**TOWN OF NEWBURGH  
PLANNING BOARD  
TECHNICAL REVIEW COMMENTS**

**PROJECT NAME:** NEWBURGH COMMONS  
**PROJECT NO.:** 23-24  
**PROJECT LOCATION:** SECTION 9, BLOCK 1, LOT 53.1 & 13  
**REVIEW DATE:** 1 DECEMBER 2023  
**MEETING DATE:** 7 DECEMBER 2023  
**PROJECT REPRESENTATIVE:** JMC PLANNING ENGINEERING

EXISTING CONDITIONS AND LOT CONSOLIDATION PLAN  
NEWBURGH COMMONS  
5430 & 5450 ROUTE 9W  
TOWN OF NEWBURGH, NY 12550

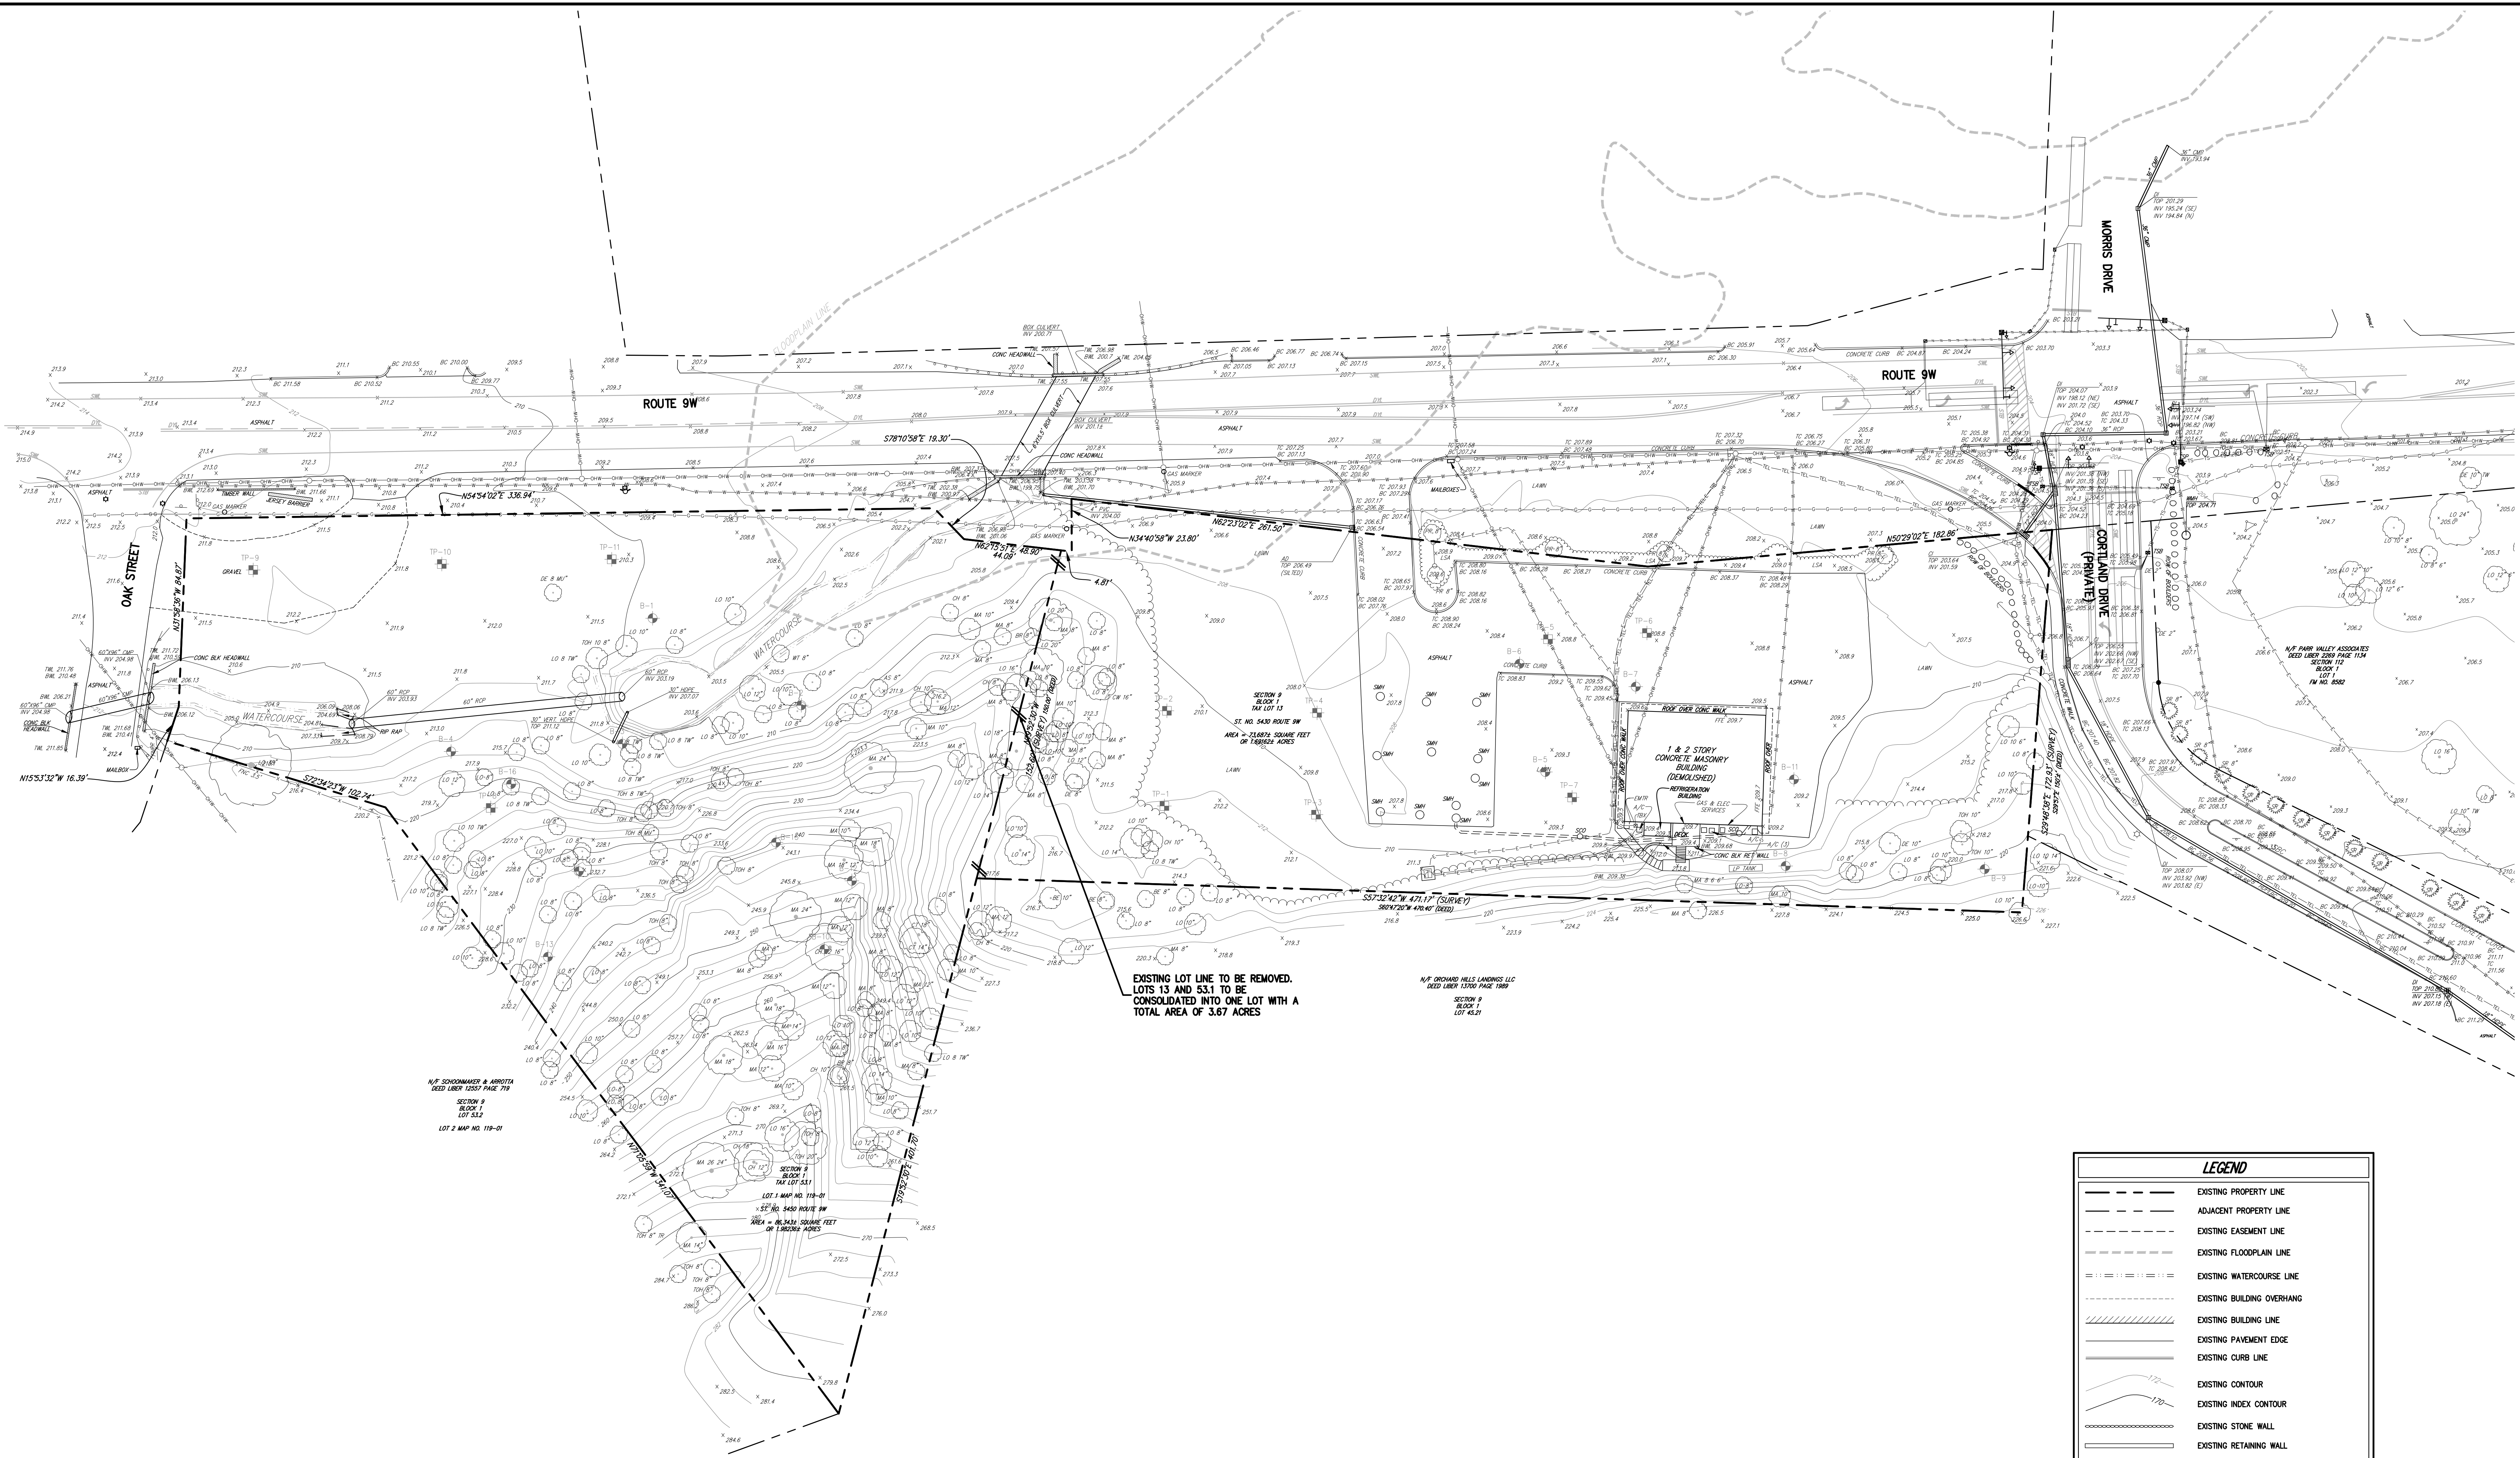
4. A Stormwater Pollution Prevention Plan will be required to be developed.
5. A Flood Plain Development Permit will be required. The location of the flood plain should be delineated on the Site Plan.

**LAYOUT PLAN**  
**NEWBURGH COMMONS**  
 5450 & 5450 ROUTE 9W  
 TOWN OF NEWBURGH, NY 12550

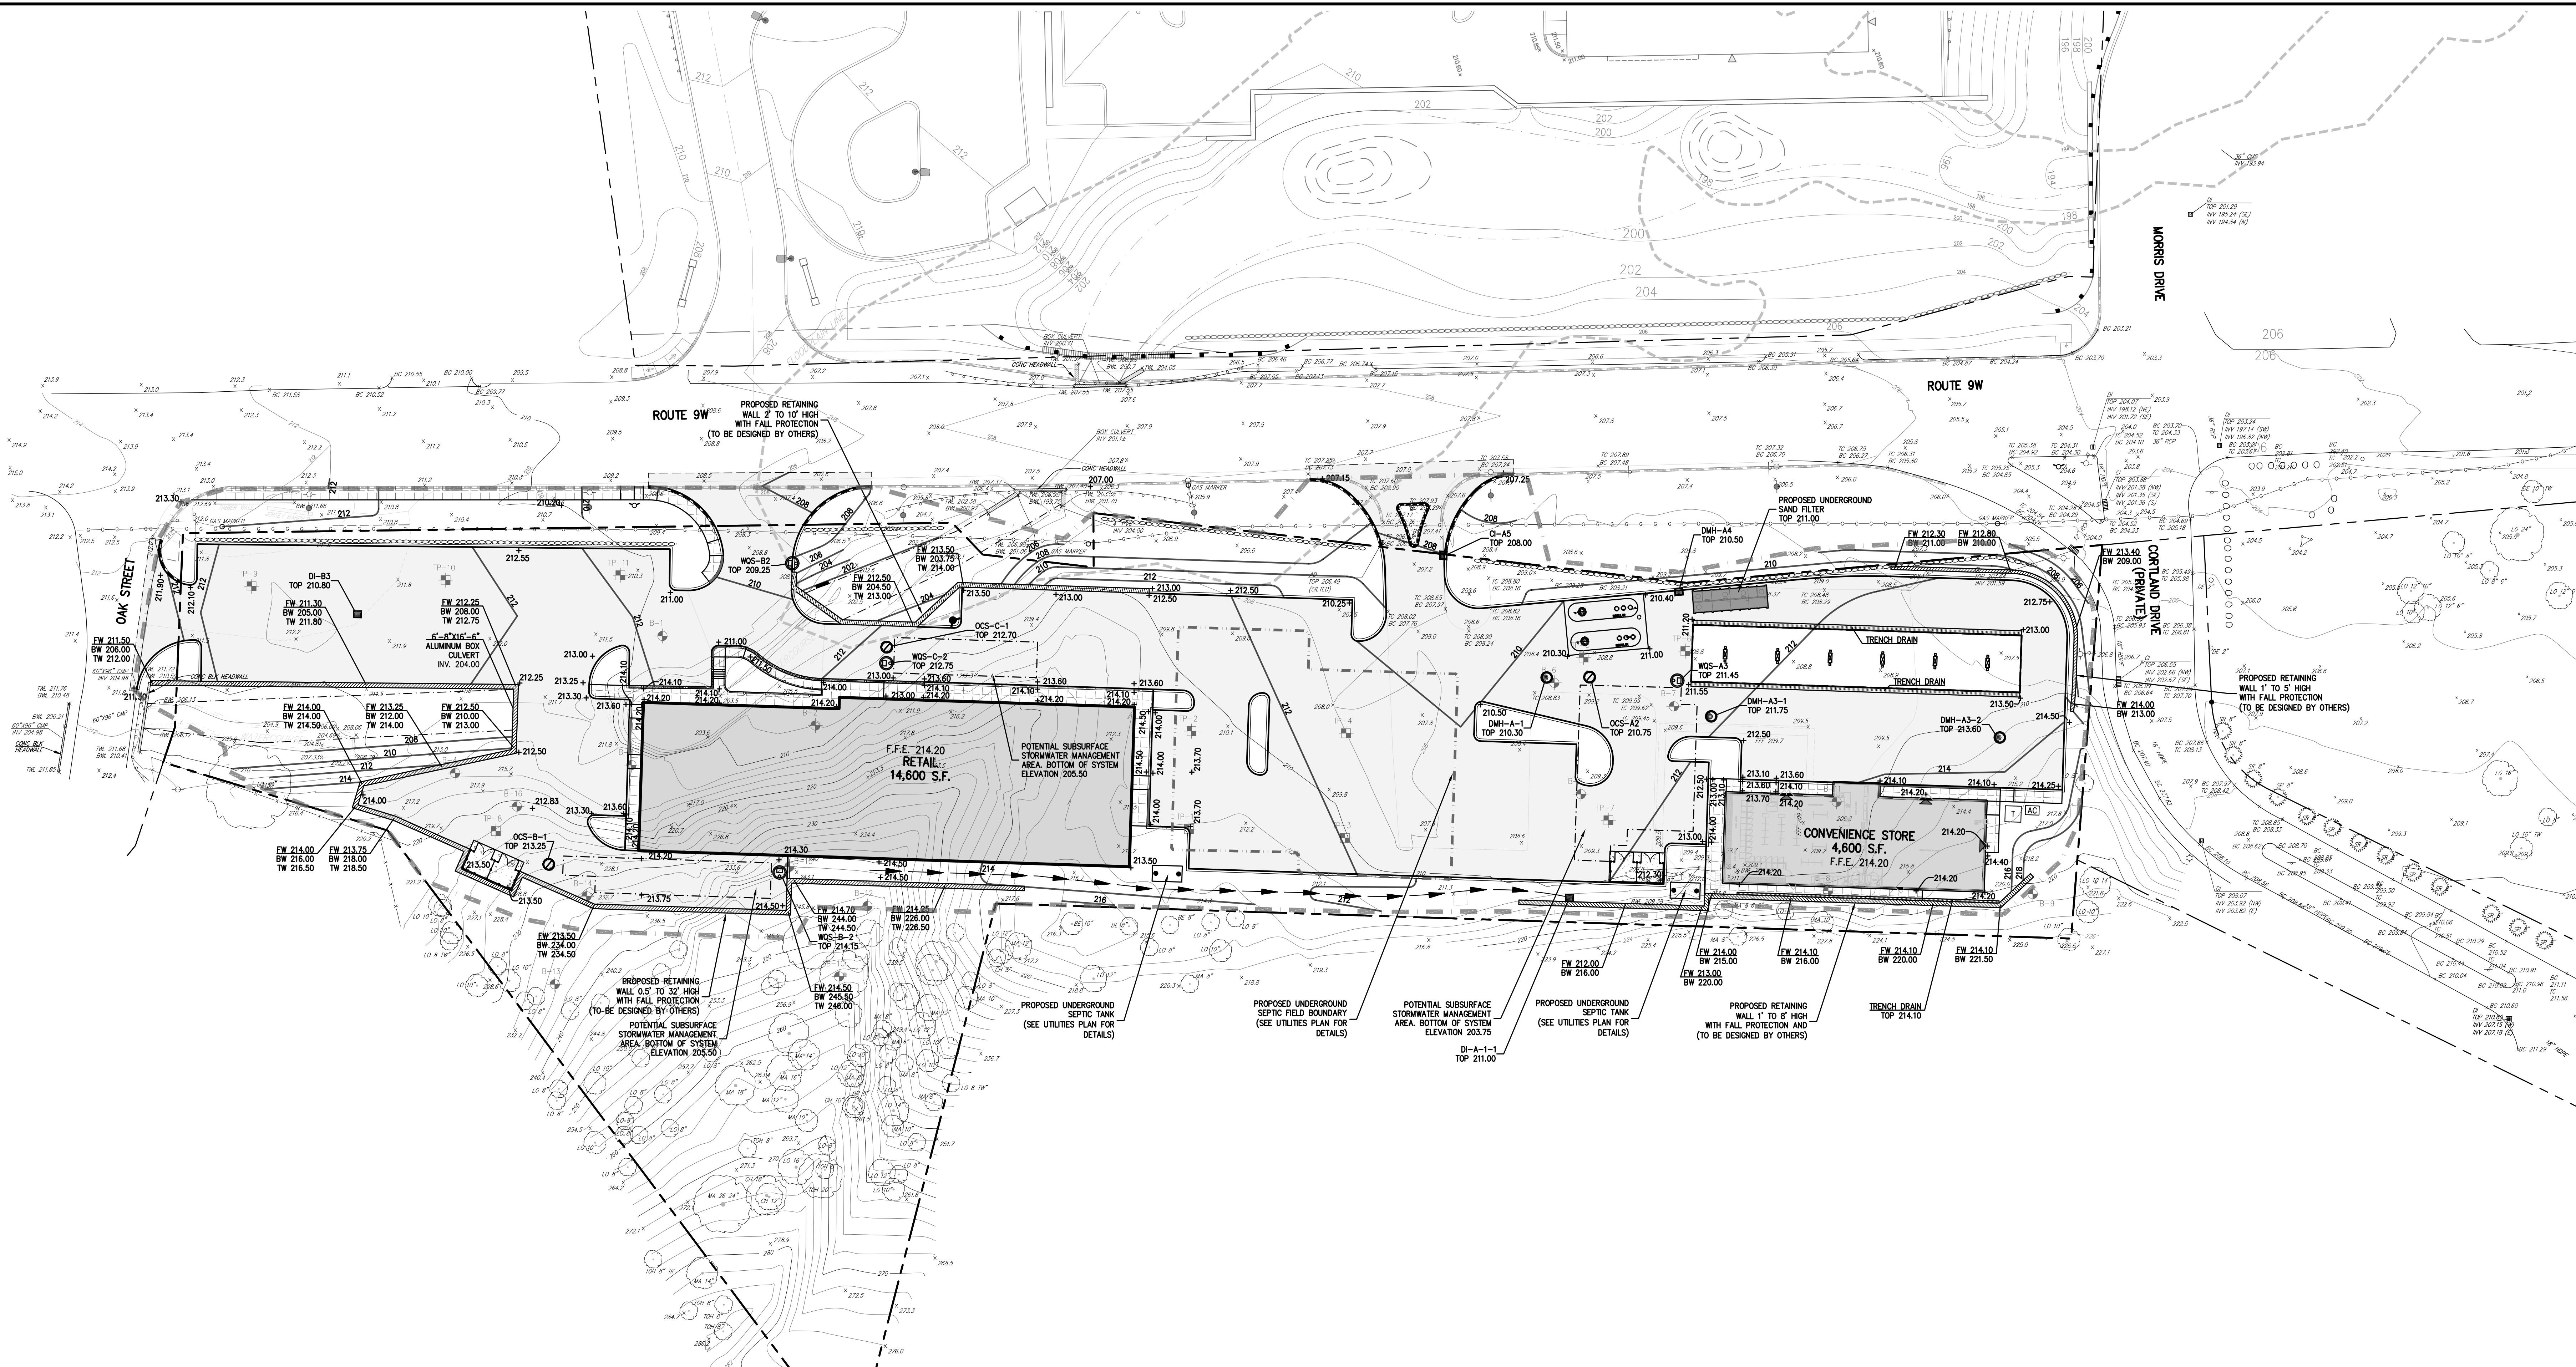
6. The entrance to Oak Street does not appear to comply with Chapter 185-13B(6) No entrance or exit for an accessory off-street parking area with over 10 parking spaces or any loading berths shall be located within 150 feet of a street intersection.
